# **Levy Nuclear Plant, Units 1 & 2**

## **COL Application**

## **Technical Specifications**

**Section A. PSTS and Bases Differences from the DCD GTS and Bases (LNP COL 16.1-1)**

FIGURE 4.1-1 Site and Exclusion Boundaries

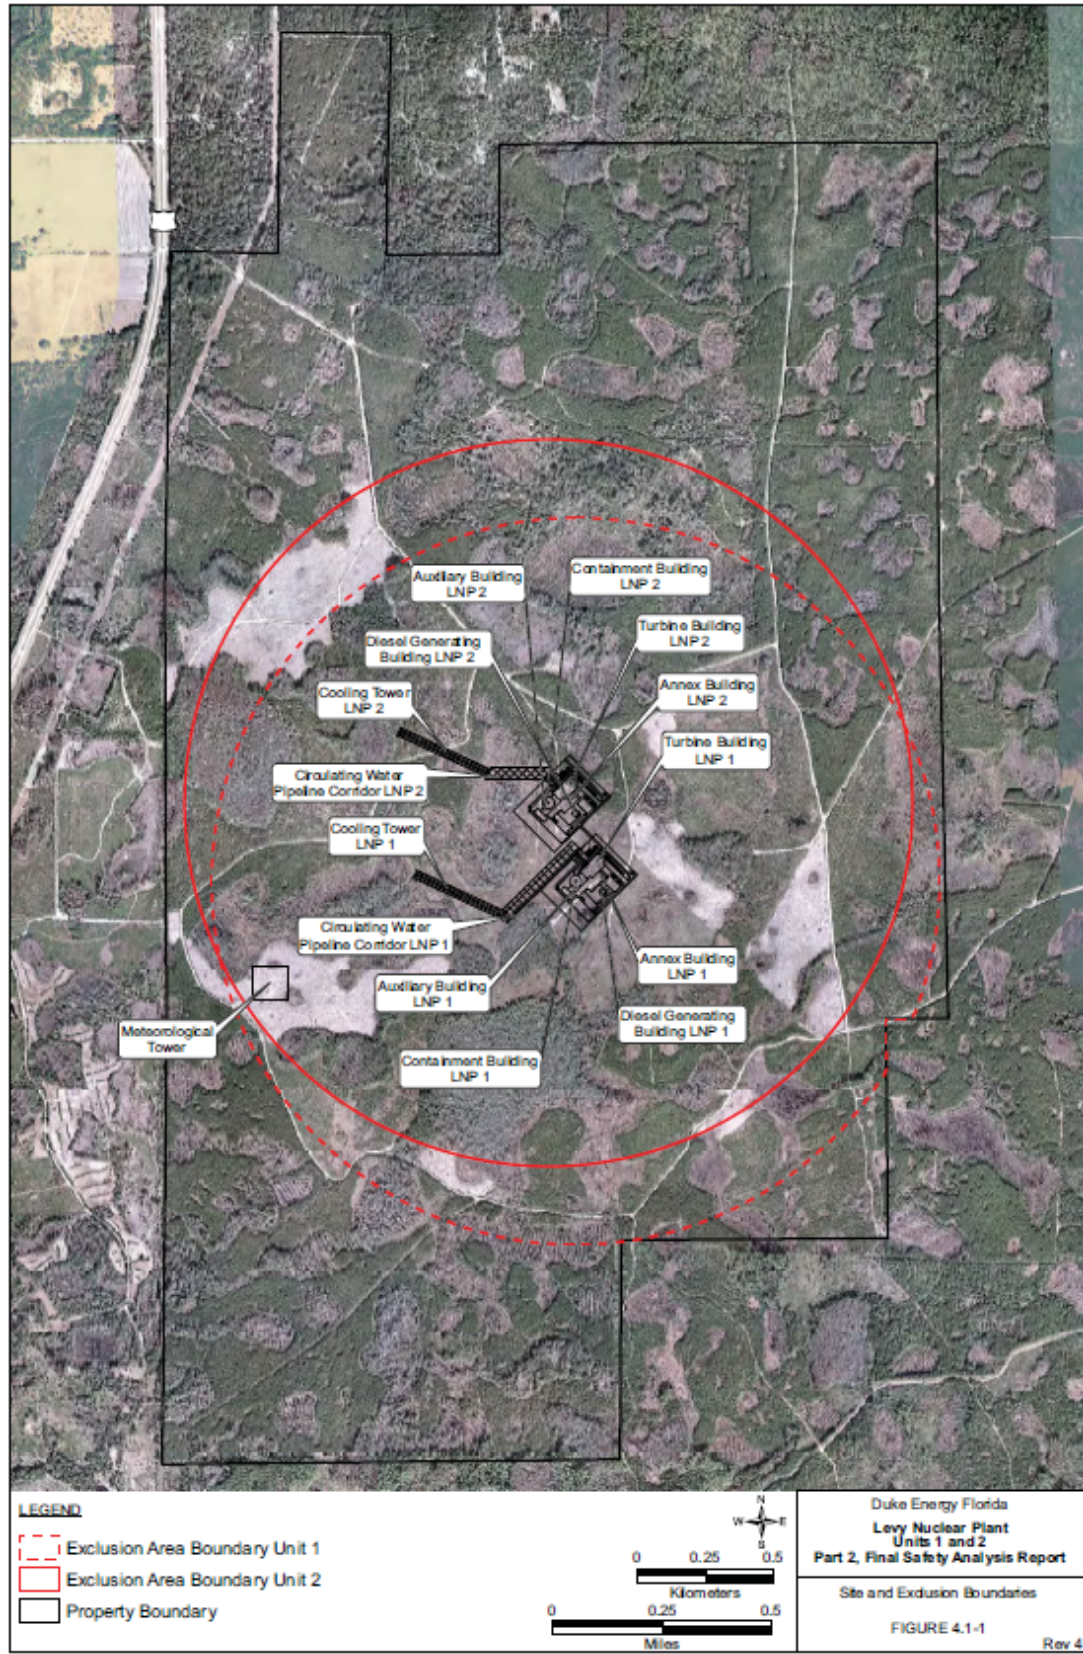
GTS 4.1.1      The bracketed information in the GTS reads:  
[This information will be provided by the combined license applicant.]

Replace the bracketed information in the GTS with the following:  
The Site and Exclusion Area Boundaries are shown in Figure 4.1-1.

Justification:  
Bracketed information is replaced to establish Site Boundary and Exclusion Area Boundary for LNP consistent with the descriptions identified in FSAR Sections 2.1.1.2 and 2.1.1.3.

FIGURE 4.1-2 Low Population Zone (LPZ)

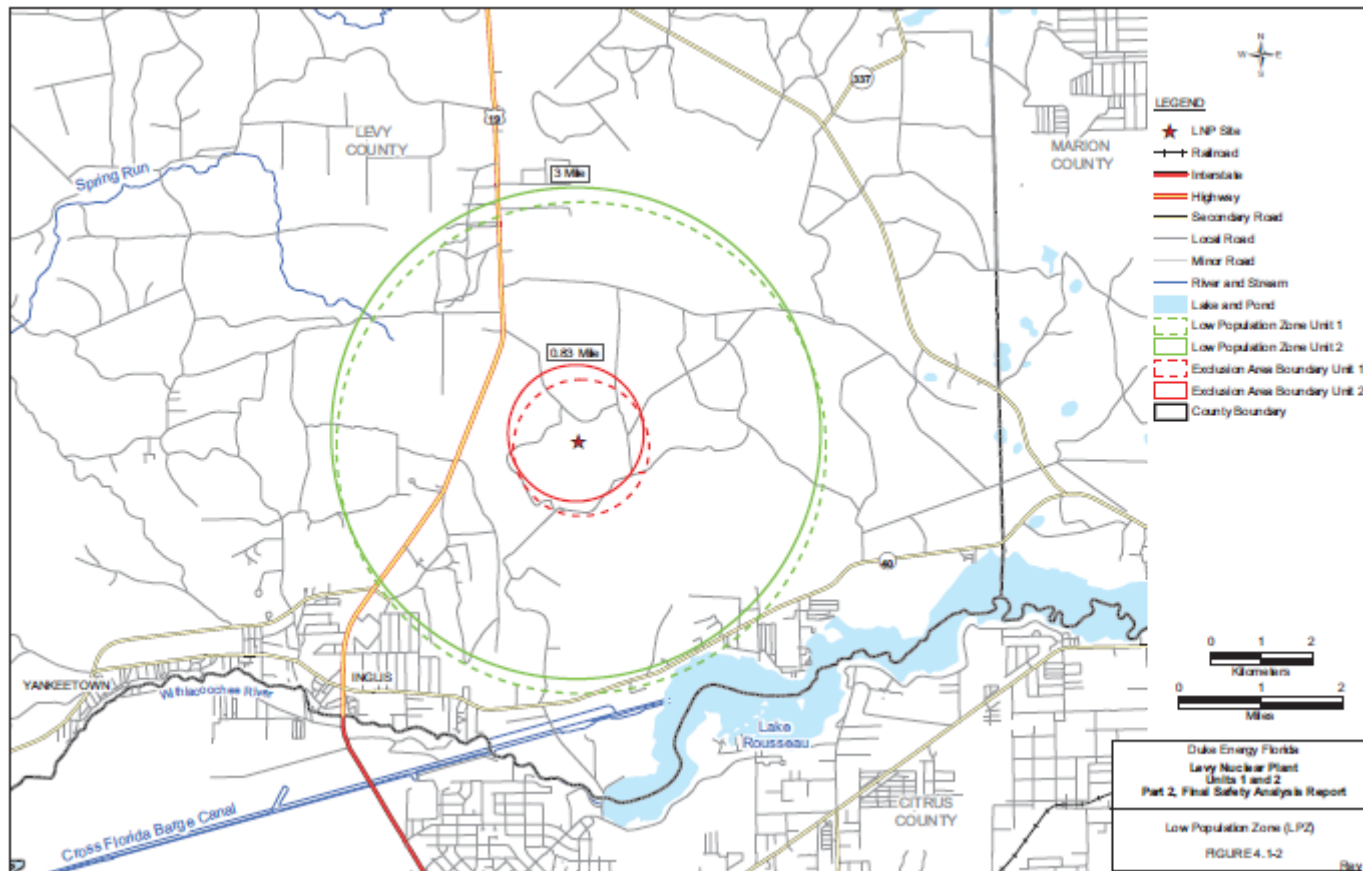
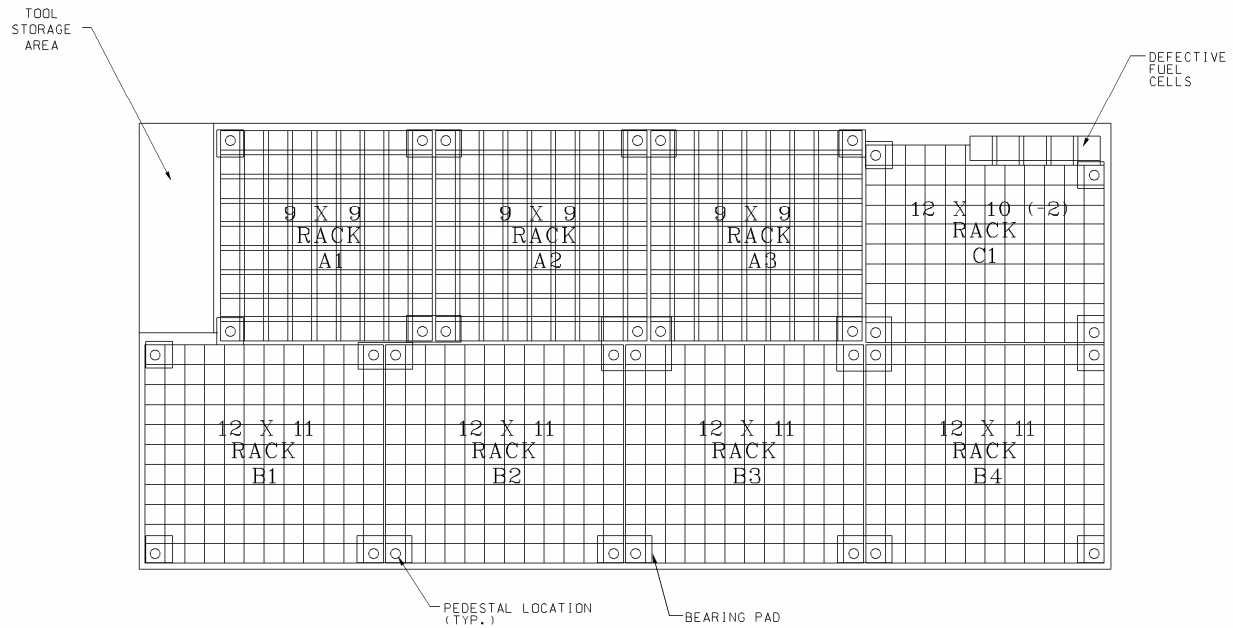
GTS 4.1.2      The bracketed information in the GTS reads:  
[This information will be provided by the combined license applicant.]

Replace the bracketed information in the GTS with the following:  
The LPZ is defined by the 3 mile radius from the site center point as shown in Figure 4.1-2.

Bracketed information is replaced to establish the LPZ for LNP consistent with the descriptions identified in FSAR Section 2.1.3.4.

Figure B 3.6.8-1 (page 1 of 1)  
Time Prior to Coolant Inventory Boiling

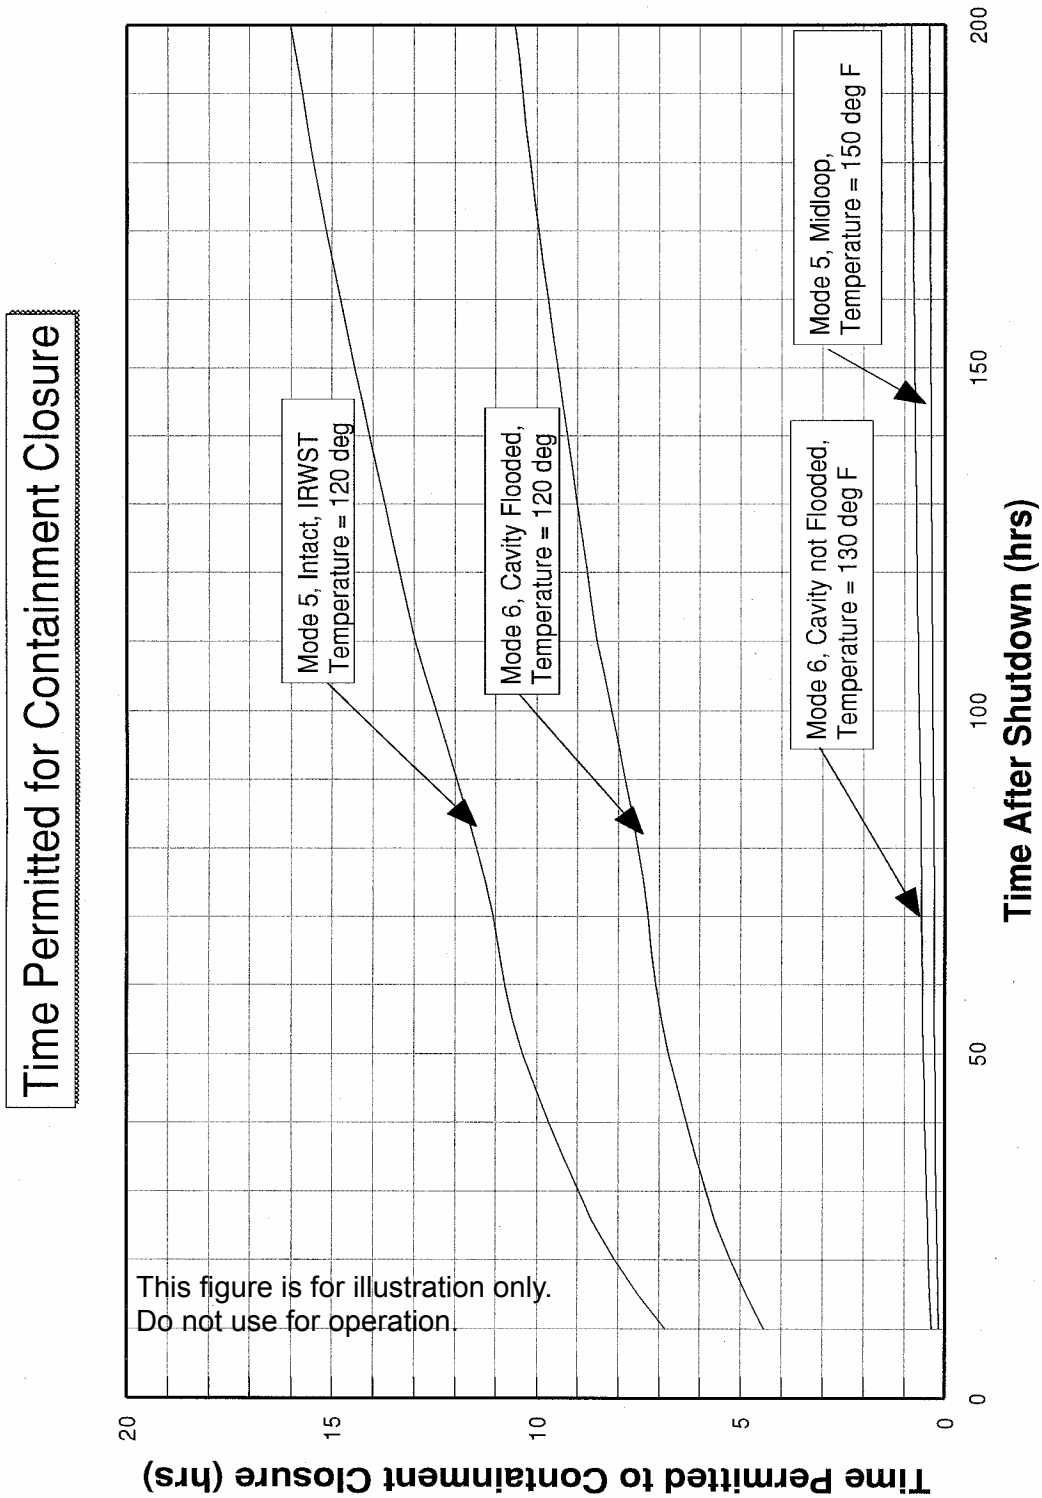
- GTS B3.6.8      The Bases for Specification 3.6.8 contain a bracketed figure which addresses the anticipated time prior to coolant inventory boiling under various conditions.

Remove the reviewer note in the PSTS. There is no replacement language.
